DEVIATION REQUEST (Attach diagrams, figures, and other documentation to clarify request)

CURTIS 2-LOT SUBDIVISION

SITE DEVELOPMENT PLANS
1920 E BAPTIST RD. MONUMENT, CO 80132

2-LOT MINOR SUBDIVISION
DEVELOPMENT PLAN

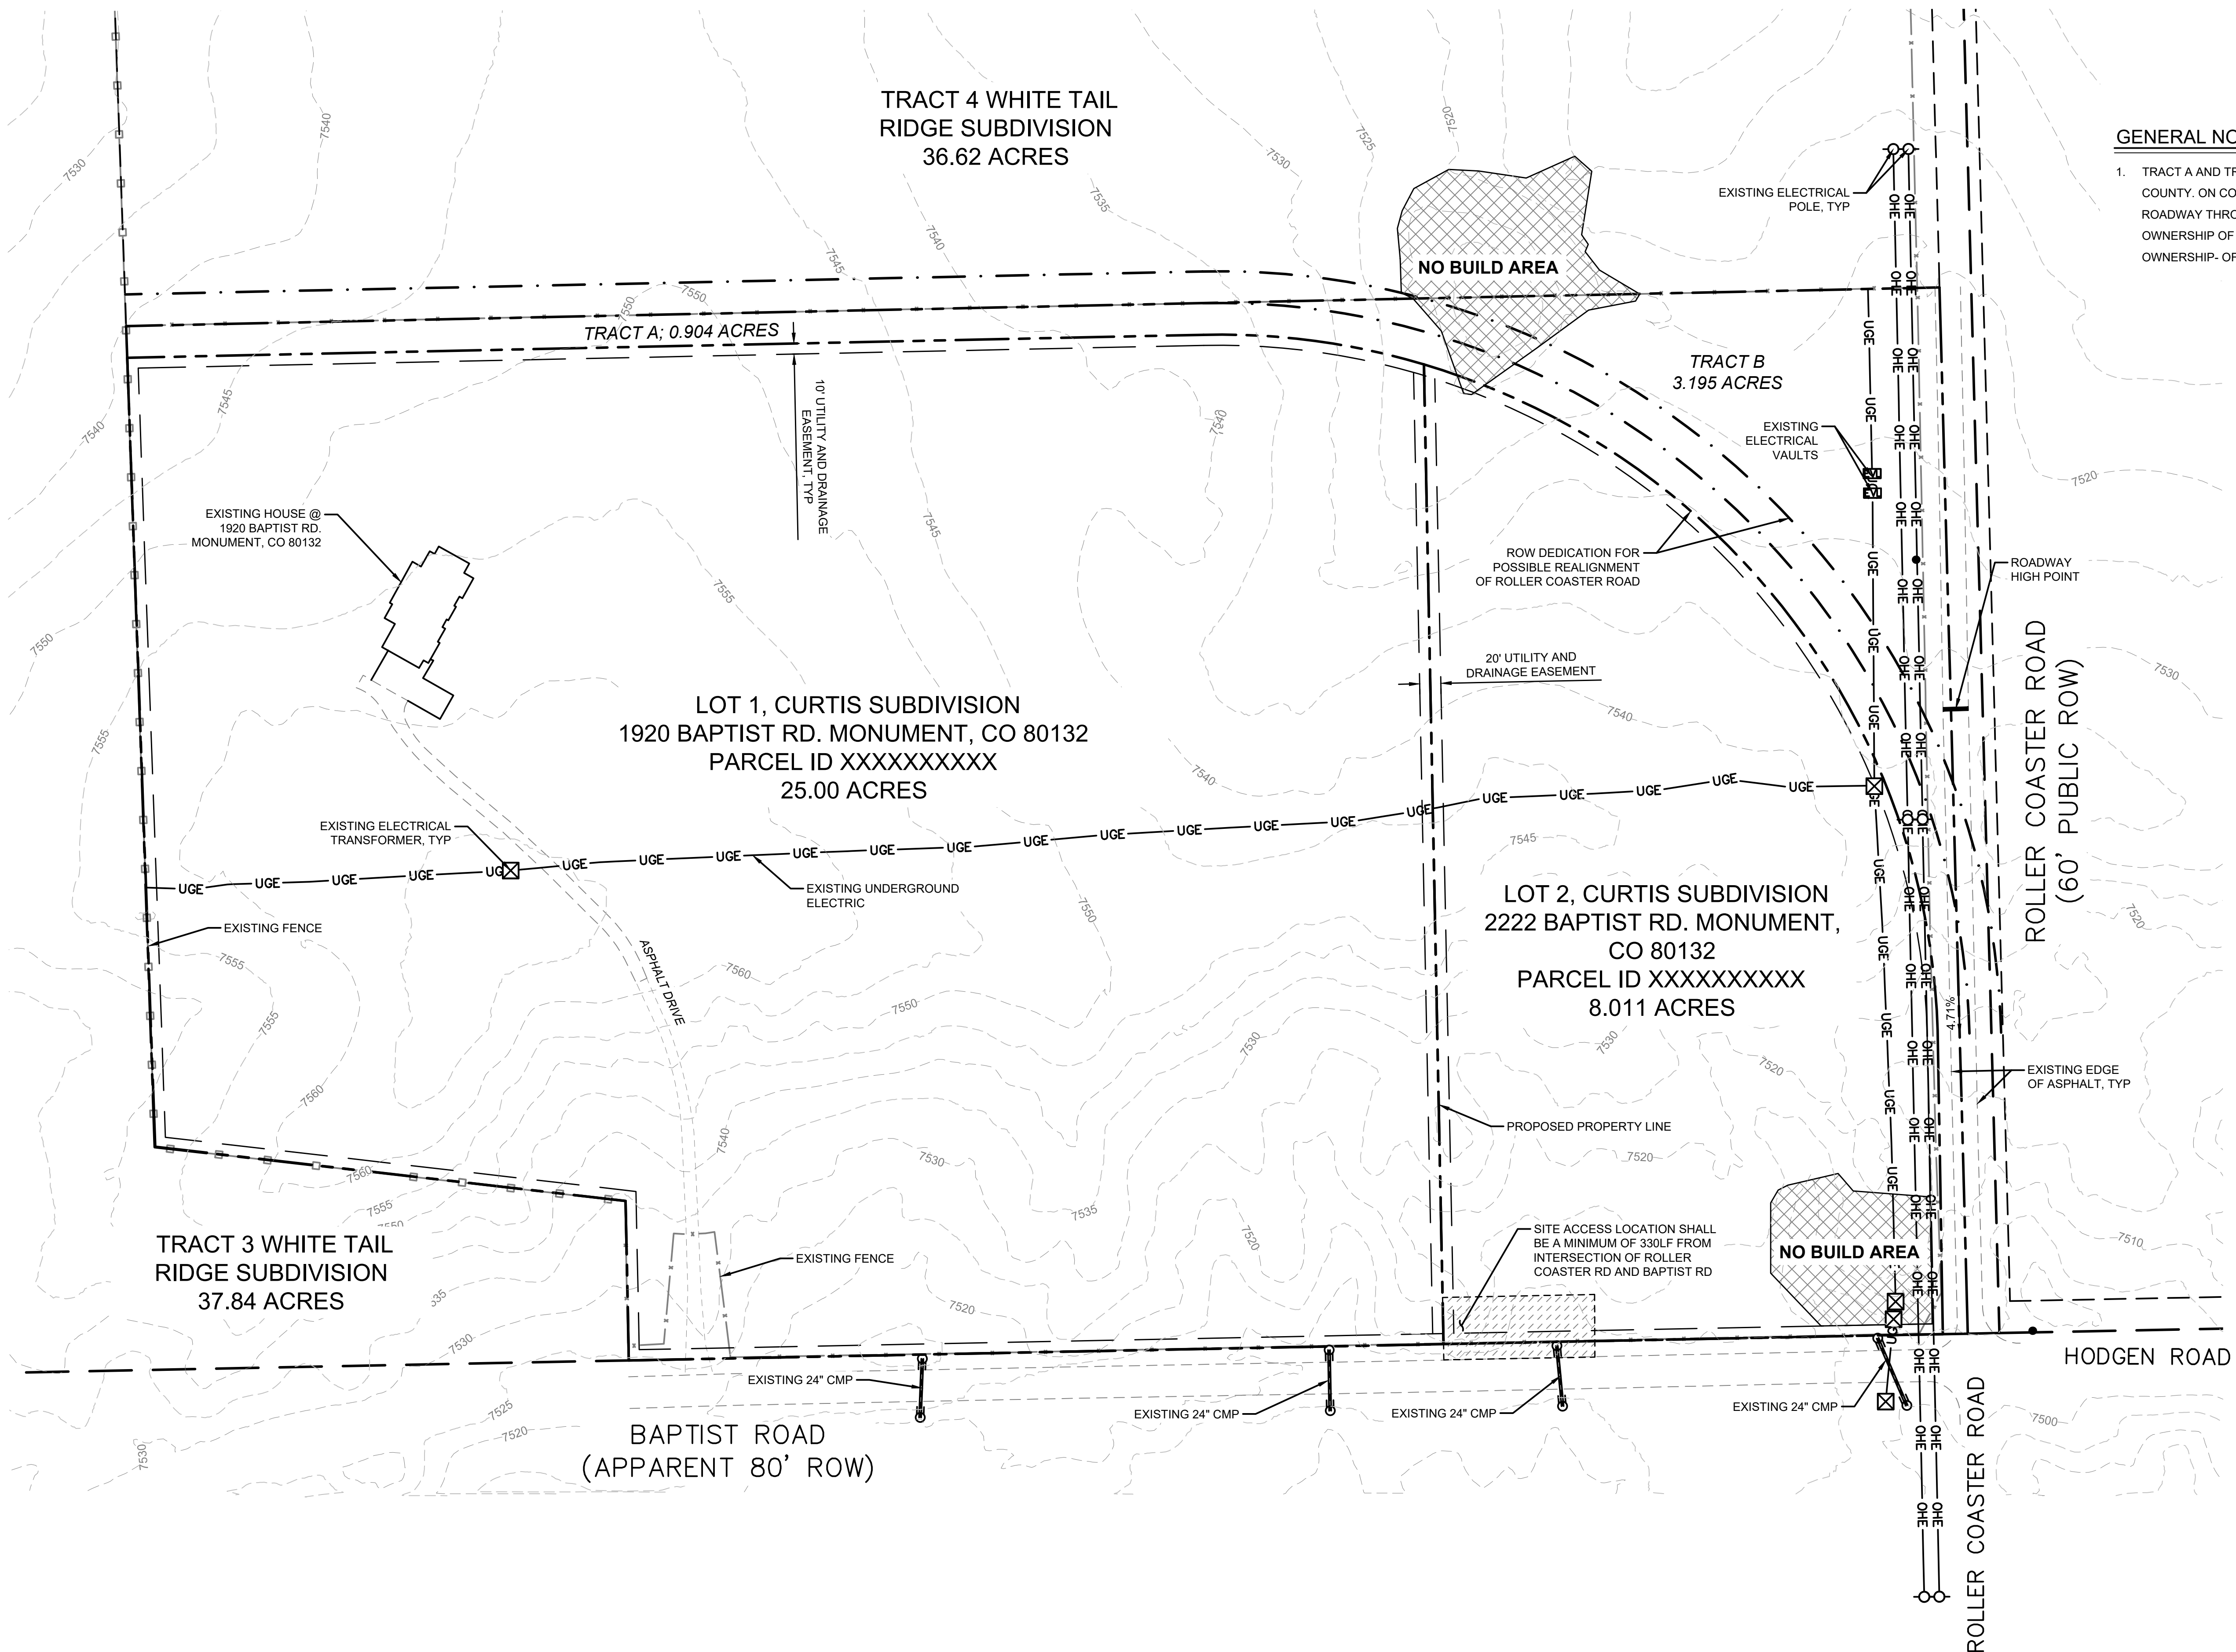
Currently, a new access off Baptist Road has been deemed unacceptable at the property in question. In order to gain access to the property without having an access off Baptist Road, there would have to be one along Roller Coaster Road, where the speed limit is 50 mph and there is a large vertical curve in the road near the property, which causes a dangerous blind spot. The high point of this vertical curve is located near the northeast corner of the property. The slope of this roadway is an average of just over 5% from the intersection of Baptist Road and Roller Coaster Road to the roadway high point to a slope of 4% from the high point to the north. Site distance shall be met with the proposed location of the driveway along Baptist Road, as set forth in the CDOT Roadway Design Guide. The top of the vertical curve is located within the tract of land being provided to El Paso County, and therefore no access can be located here. For safety reasons, approval for an access off Baptist Road at least 330 feet from the intersection of E Baptist Road and Roller Coaster Road is requested.

It is proposed that an access to proposed Lot 2 in Curtis Subdivision Filing No. 1 be constructed a minimum of 330 feet from the intersection of Baptist Road and Roller Coaster Road. Currently, El Paso County does not allow additional access points off Baptist Road at this location. However, there is a serious safety concern with the alternative, possible access location off Roller Coaster Road. Not only is the speed limit lower along Baptist Road (40 mph in this area compared to 50 mph along Roller Coaster Road), but there are no dramatic vertical curves in the road causing blind spots. In addition, the access will not be too close to an intersection and will be placed a minimum of 330 feet from Baptist and Roller Coaster Road. This will lead to a much safer situation for not only the owners of Lot 2 in Curtis Subdivision Filing No.1, but also other drivers on the road.

A deviation from ECM standard 2.3.2 Design Standards by Functional Classification, Table 2.4, indicating that access is not permitted on an arterial road. El Paso County Planning directly requested a deviation request be submitted for a designation of access location at the property in question. The topography of the area in question creates a safety concern along Roller Coaster Road, as an access along this roadway would be near a dramatic vertical curve. This blind spot imposes an undue hardship on not only the Owner’s of the property, but to individuals driving along this roadway.

This request has been determined to have met the criteria for approval. A deviation from Section 2.3.2 of the ECM is hereby granted based on the justification provided.

This access is approved with the condition that when the road is constructed on the northerly side of these lots, that access will be moved to Roller Coaster Road upon the County's request.
